Memorandum

Reference: Fountain Green Fish Hatchery
Department of Natural Resources
Division of Wildlife Management
DFCM Project No 97034520

Subject: **Addendum 3**

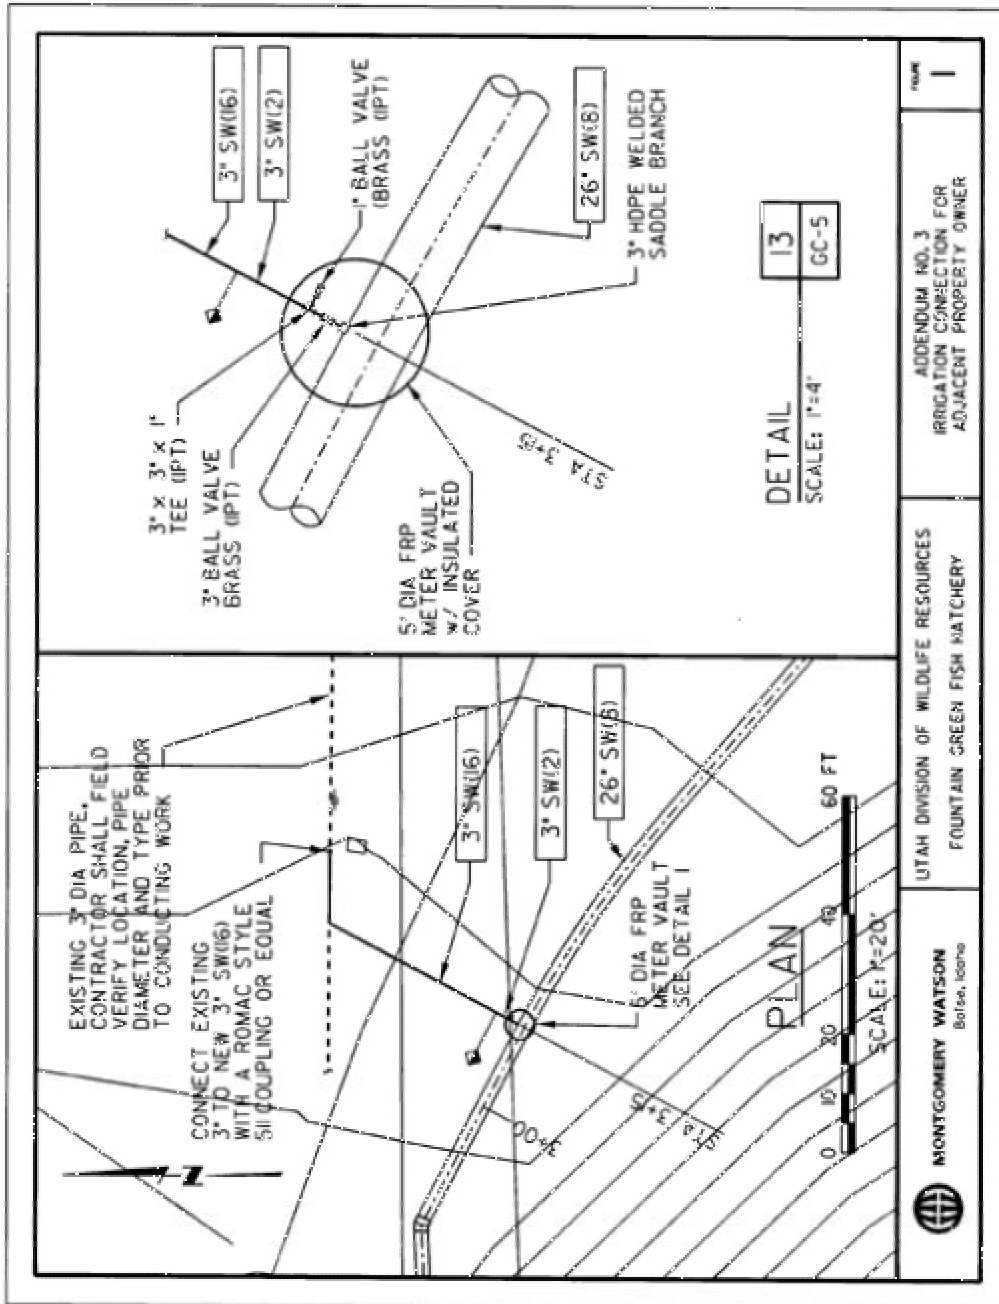
Contractor shall add Detail No. 1 (see attached drawing) to Sheet GC-5 as Detail 13.
